# NEW YORK STATE DEPARTMENT OF ENVIRONMENTAL CONSERVATION

**Re: 820 Linden Ave Site (#C828200)**  
**820 Linden Ave, Pittsford, NY 14625**  
**Revised Limited Supplemental Remedial Investigation Work Plan;**  
**February 21, 2019**

**Re: 820 Linden Ave Site (#C828200)  
820 Linden Ave, Pittsford, NY 14625  
Dispute Resolution Notice**

**Septic System #3 (northwest)**

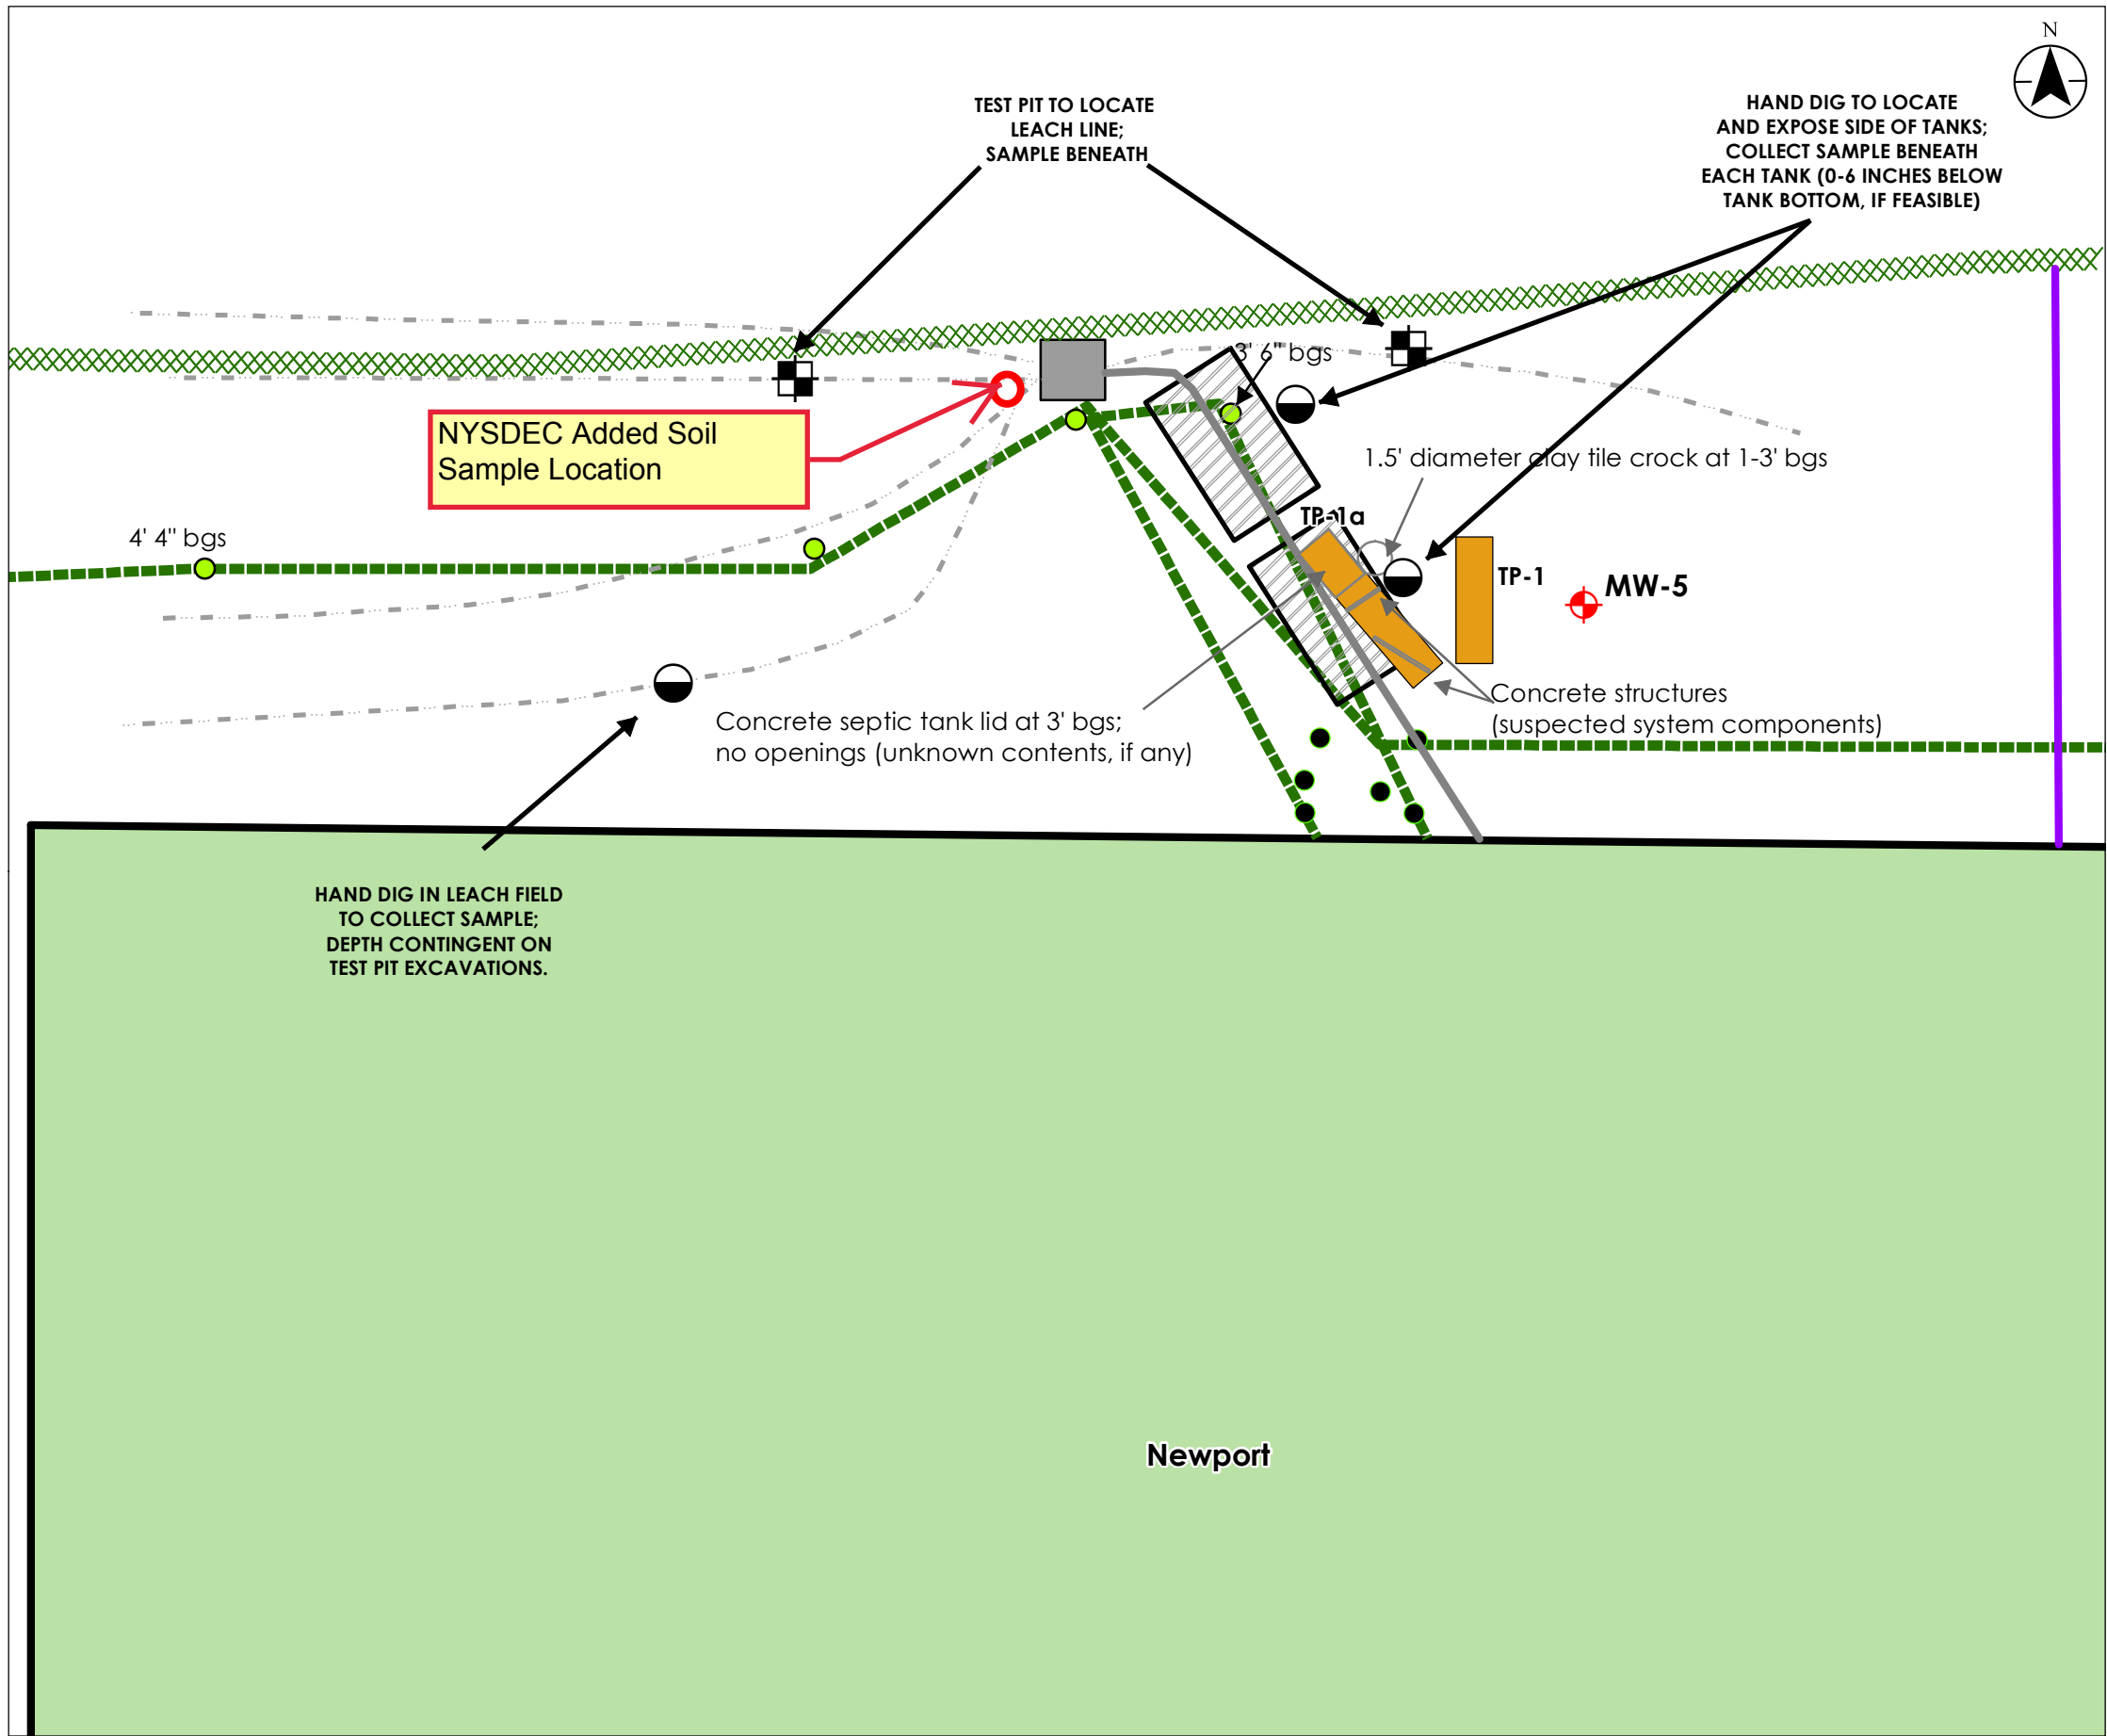
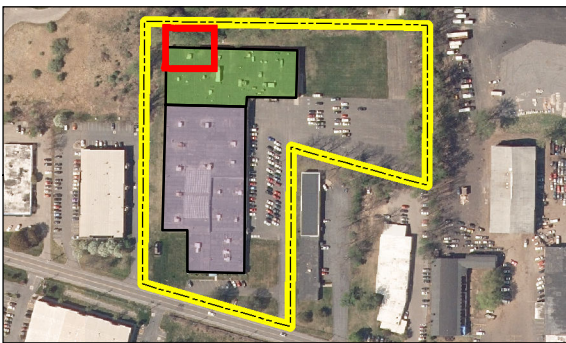
1. Section 4: To be consistent with section 3.9(e) of DER-10, one additional soil sampling location, will be collected from the Septic System #3 (northwest) leach field. The location, identified as LF-4, is shown on the attached modified Figure 2c. The qualified environmental professional will determine if the additional location will be a test pit or soil boring.
